ADDENDUM NO. ONE
NCSB -FBMS

To the Plans and Specifications for:
Nassau County School Board – Project No. 98110-031
Fernandina Beach Middle School Kitchen / Dining Remodeling and Campus
Renovations/Enhancements

Date: October 15, 2018

SECTION 216
SCALE: 3/4" = 1'-0"

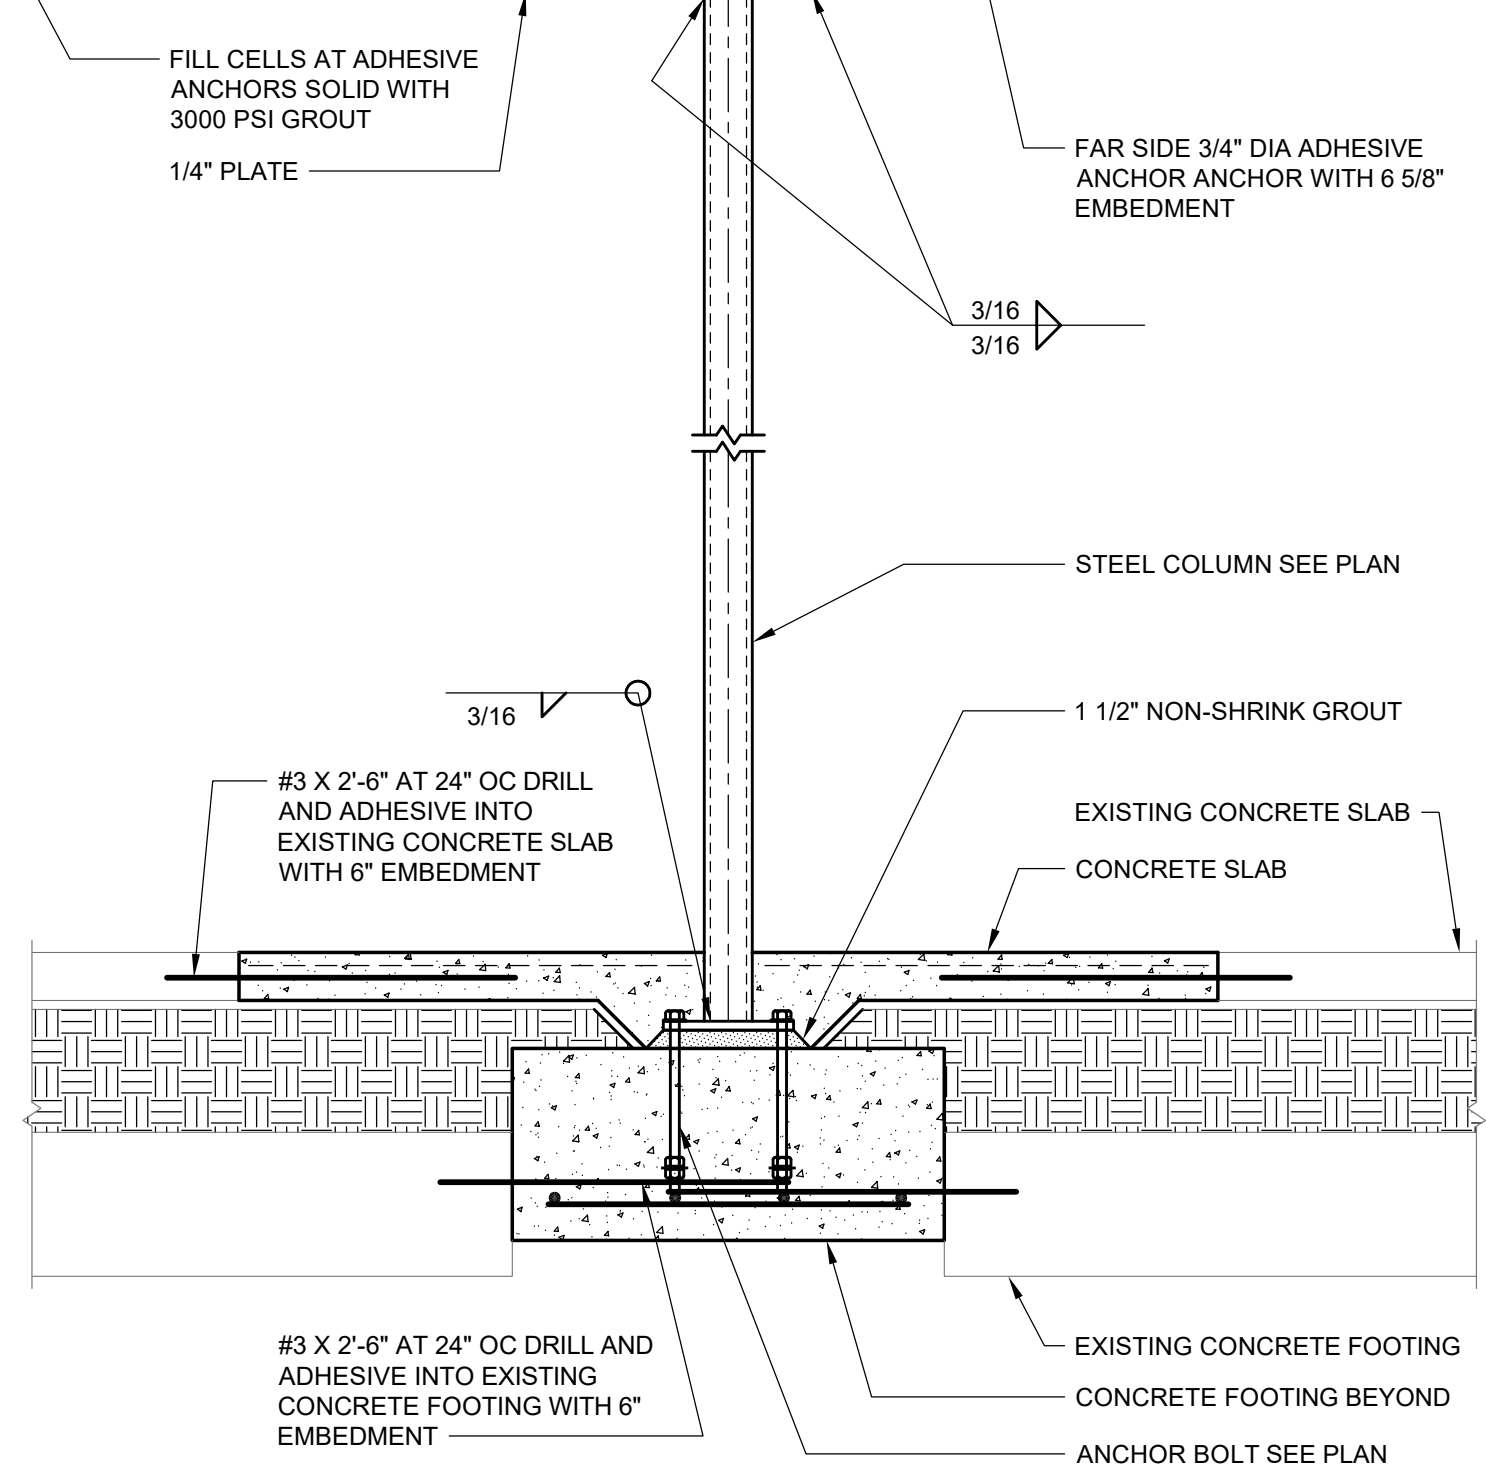
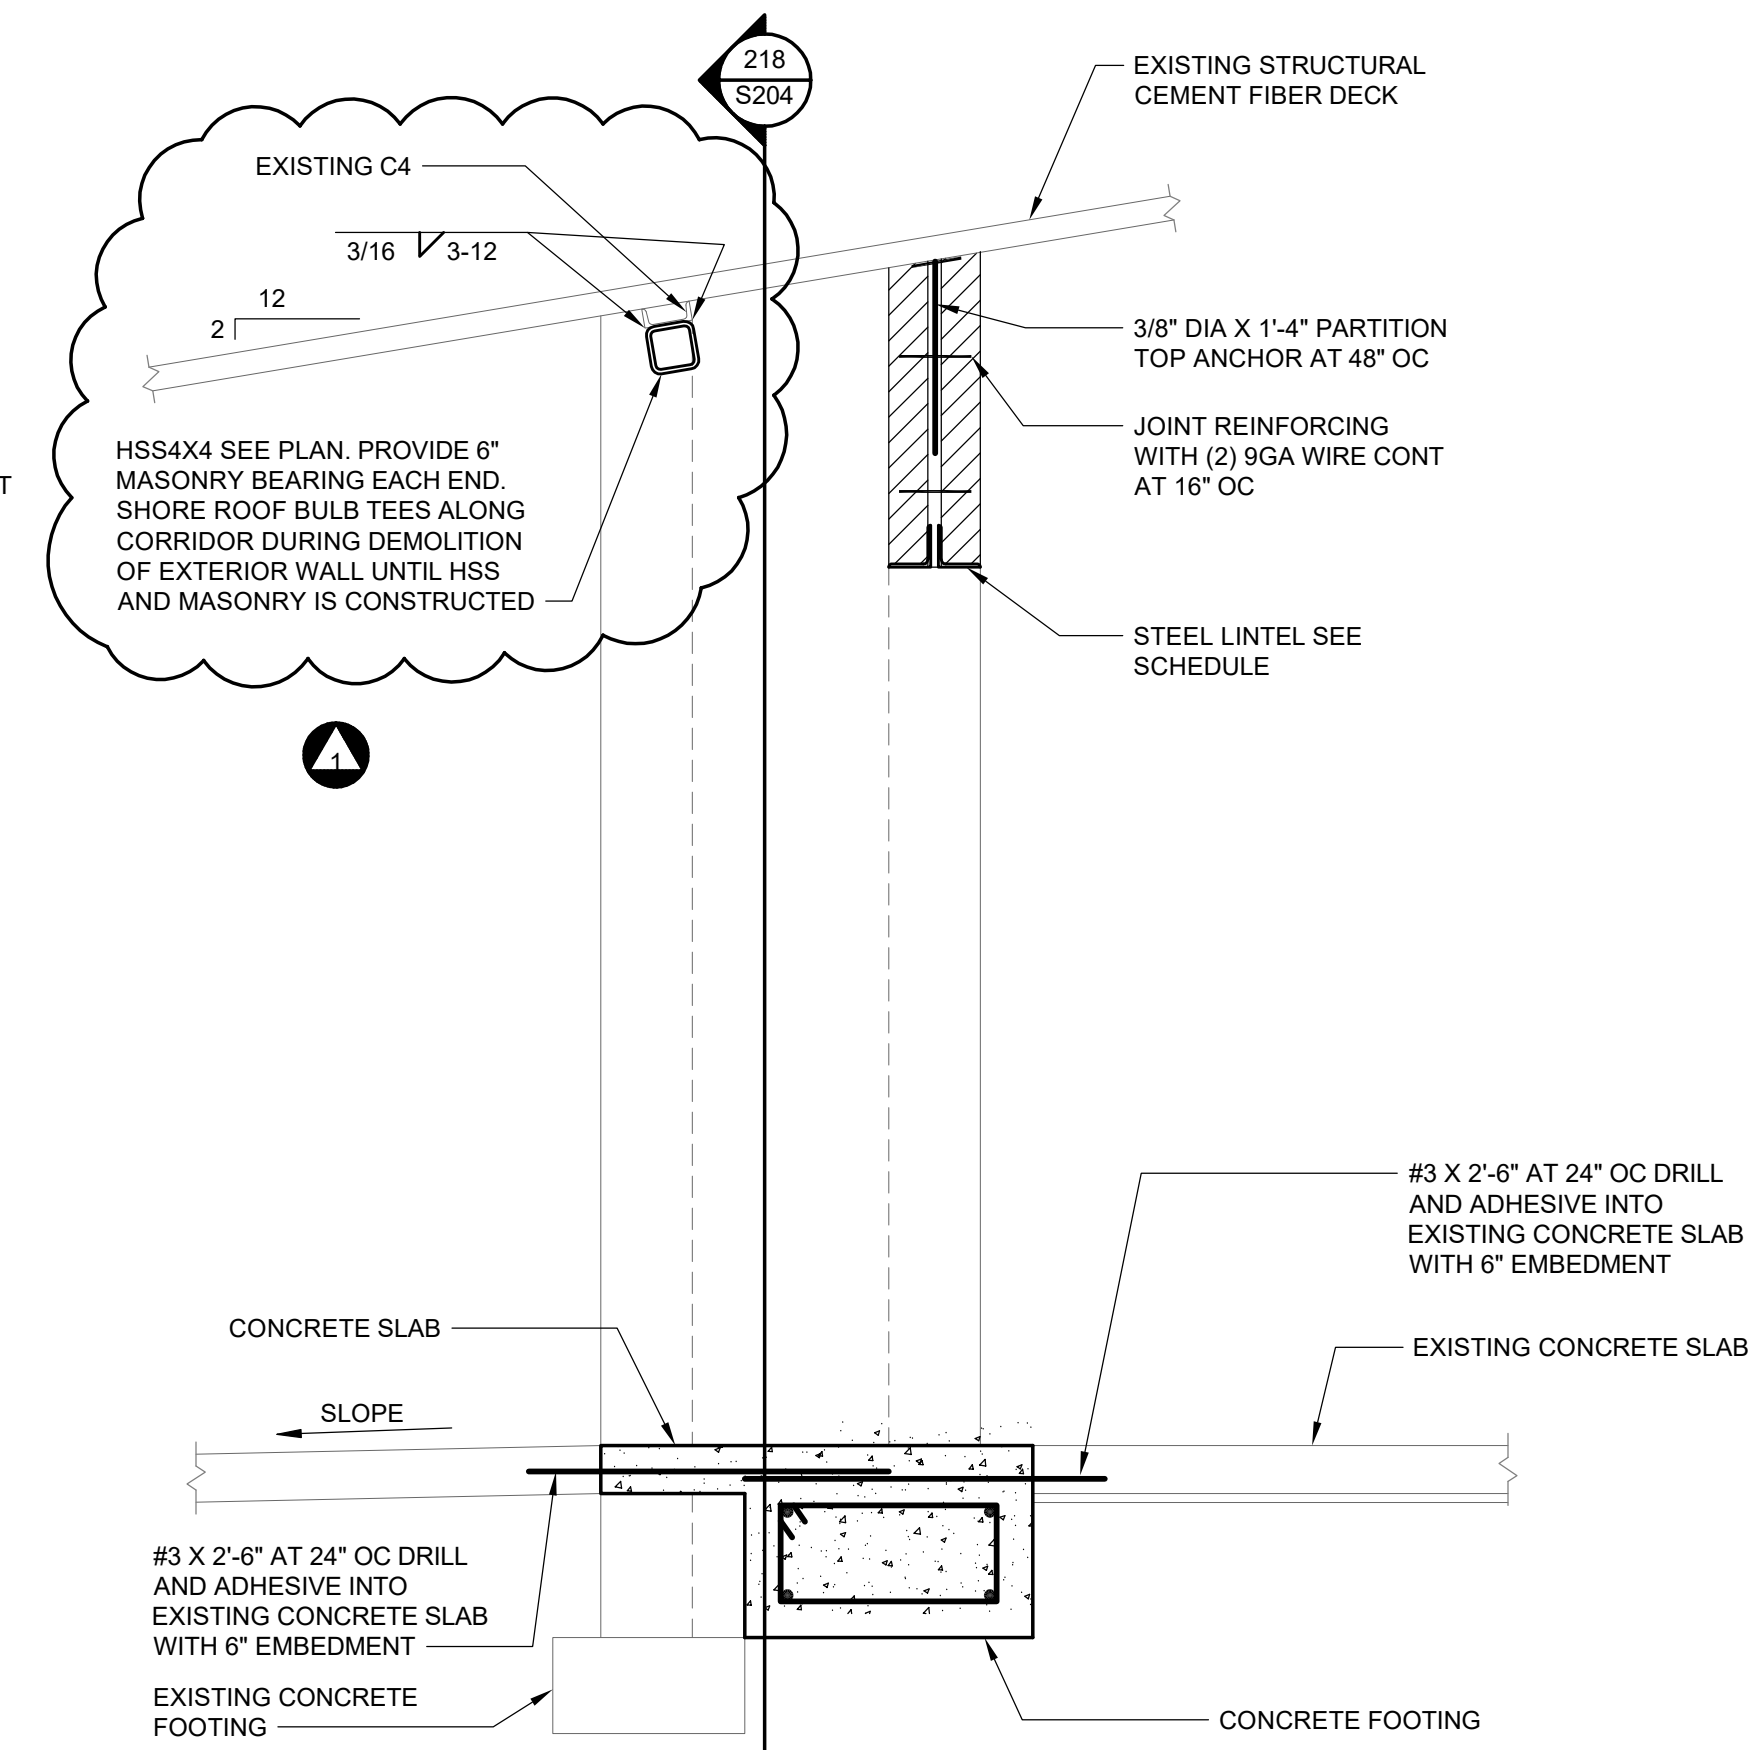
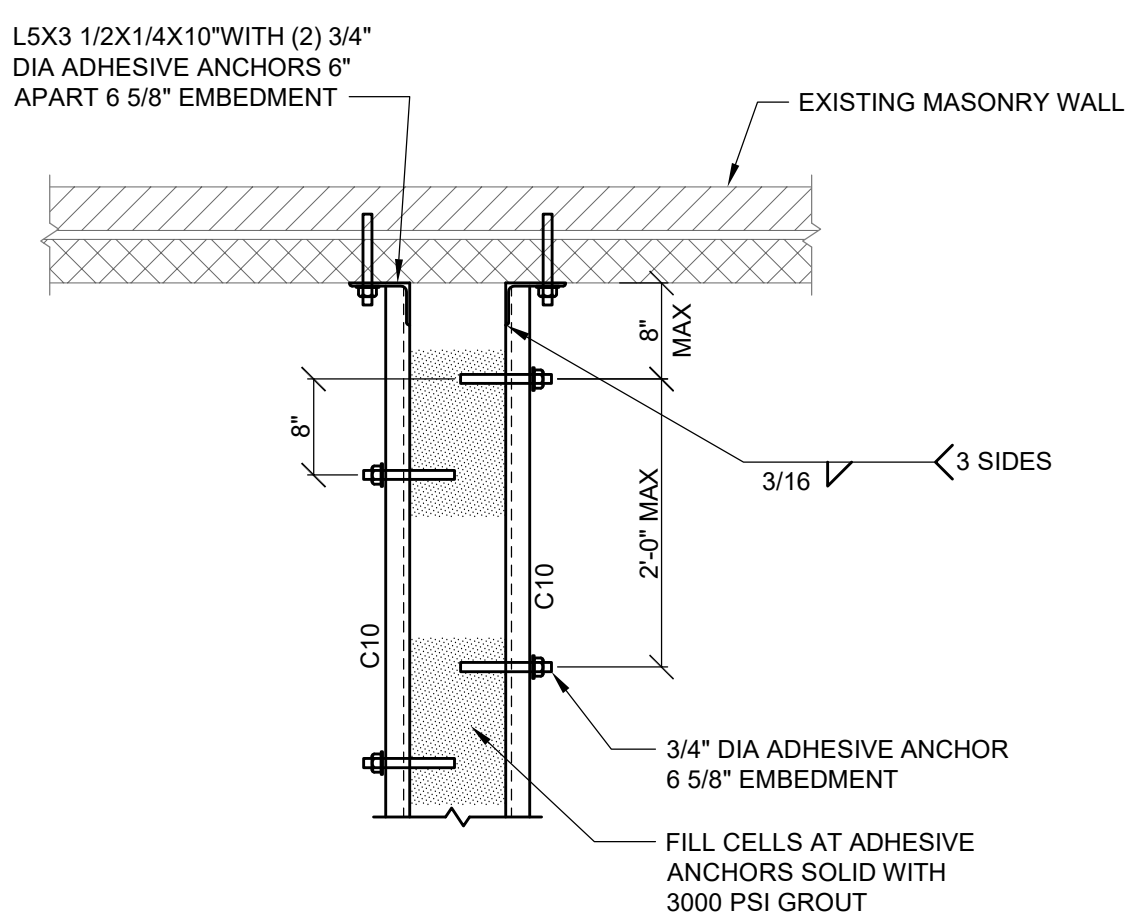
Refer to attached Sheet S102 and S203for changes to the Structural Drawings.
